Access Compliance Report

Public Rights-of-Way

(Curb Ramps)

Intersection ID: 2934	Main Street: CHINQUAPIN_CT	Cross Street: LADY_BANK_DR	Location: NW
ADA ID: EEBE115CD548	Ramp Type: PerpDiag	Initial Pass/Fail: Fail	Overall Compliance: No
Severity Score: 12.5			
Codes/Mitigation Info/Possible Solution		Field Measurements/Component Compliance

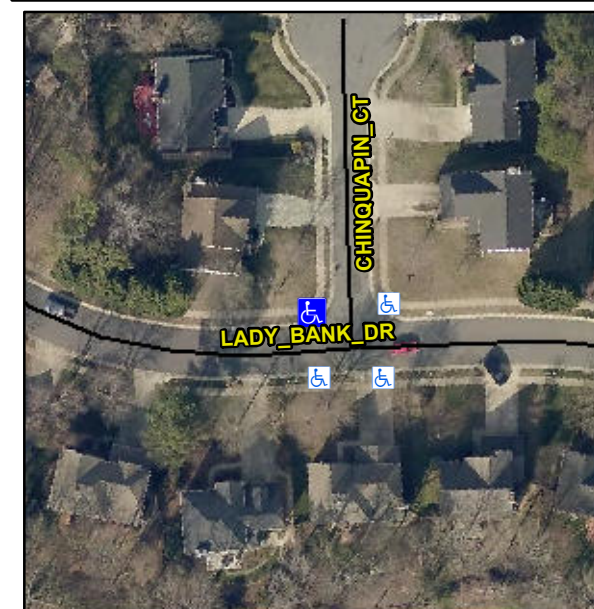
Not Found, R304.2.2

Compliance	Description	Data	Compliance	Description	Data
N/A	Ramp Length (in)	37.0	No	Ramp Slope (%)	8.6
Yes	Ramp Width (in)	137.0	Yes	Ramp XSlope (%)	1.5
N/A	Flare Type LT	N/A	N/A	Flare Type RT	N/A
N/A	Flare Slope LT (%)	N/A	N/A	Flare Slope RT (%)	N/A
N/A	Flare Traversable LT?	N/A	N/A	Flare Traversable RT?	N/A
N/A	Landing Length (in)	N/A	N/A	DWS Provided?	N/A
N/A	Landing Width (in)	N/A	N/A	DWS Contrast?	N/A
N/A	Landing Slope (%)	N/A	N/A	DWS Length (in)	N/A
N/A	Landing X Slope (%)	N/A	N/A	DWS Full Width?	N/A
N/A	Landing Curb? (Y/N)	N/A	N/A	DWS Offset (in)	N/A
N/A	Shared Landing?	N/A			
N/A	Gutter Ponding?	N/A	N/A	Gutter Slope (%)	N/A
N/A	Gutter Lip Ht (in)	N/A	N/A	Gutter X Slope (%)	N/A
N/A	Painted X Walk1?	No	N/A	Painted X Walk2?	No
	X Walk 1 Direction	To S		X Walk 2 Direction	To E
N/A	X Walk 1 Width (in)	N/A	N/A	X Walk 2 Width (in)	N/A
	X Walk 1 Slope (%)	5.5		X Walk 2 Slope (%)	2.7
	X Walk 1 X Slope (%)	2.8		X Walk 2 X Slope (%)	1.3

Remove & Replace Curb Ramp With Two New Directional Ramps or Equivalent.
